## PUBLIC HEARING/WORKING SESSION MEMORANDUM

### **PETITION #140-19(1), #140-19(2), and #140-19(3) 355 and 399 Grove Street**

**To:** City of Newton Planning & Development  
**From:** Peer Review Consultant Team  
(Form + Place, Horsley Witten Group, Inc., Utile, Green International, HR&A)  
**Date:** September 19, 2019  
**Re:** Riverside Station, Newton, Massachusetts  
Site Design, Open Space, and Grove Street Review

**Graphic II: Height Map**

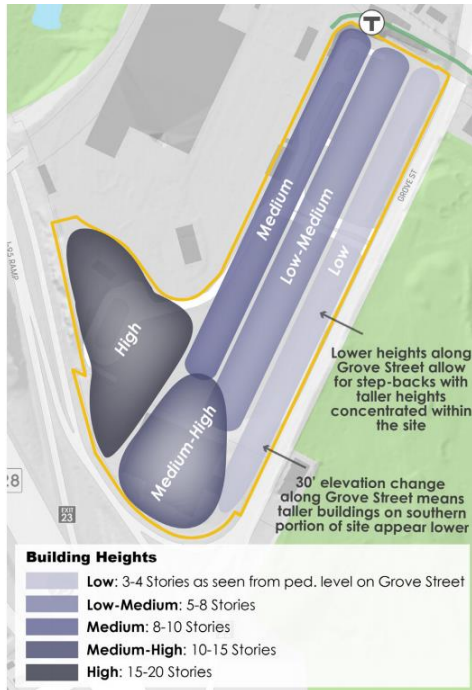
The Planning Department believes that the petition is consistent with the recommended heights identified by the Vision. Height is concentrated at the rear of the site, adjacent to the interstate while the buildings along Grove Street take advantage of grade changes across the site and provide step backs at the top floor. Buildings 4, 5, and 6 contain four stories from Grove Street with a fifth story stepped back from the story below. Building 7 is sited perpendicular from Grove Street, with limited frontage and is five stories with a sixth story stepped back from the street. The Peer Review Team found that the varied heights of the buildings, from the low buildings along Grove Street to the tall office building, makes the proposal appear as if it was developed over time and that the tall office building next to the interstate is appropriate. They stated that the buildings along Grove Street are appropriately scaled. The Peer Review Team believes the office building will add a daytime population and will attract a diversity of tenants to benefit the City and the project. The Peer Review Team also found that the presence of the buildings along the highway will serve as a gateway to the project and provide a presence critical to the success of the project, while conveying

**Graphic III: Grove Street Cross-Section**

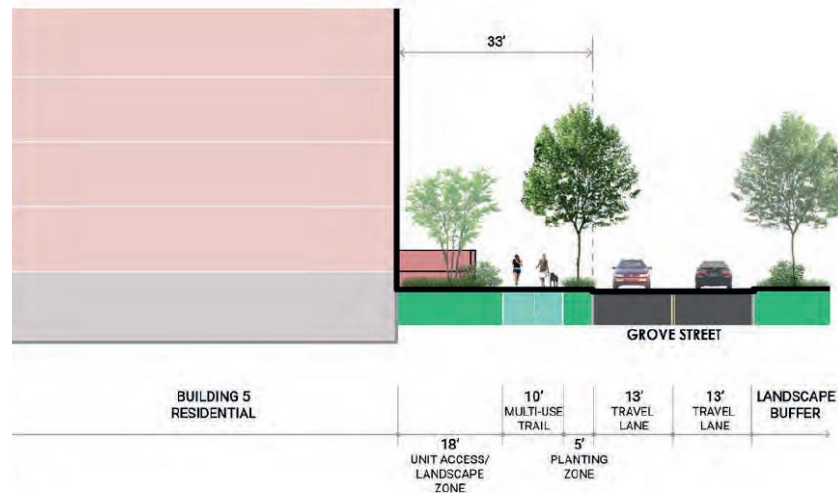
The Vision suggested that the petition include landscaping along Grove Street and throughout the site, when adding sidewalks along Grove Street, retaining or adding new landscaping/trees if setbacks exist, and providing safe pedestrian access during construction. The petitioner is proposing to provide at least five-foot-wide planting zones on both sides of all streets throughout the site, except for the southern side of Grove Street, which is outside the scope of the project. Additional information is needed on the northern side of Grove Street as the petitioner is proposing to separate the sidewalk from the bicycle track, which will affect the landscape zone shown along Buildings 5 and 6. All landscape guidelines within the site and along Grove Street will also need to be incorporated into the Design Guidelines.
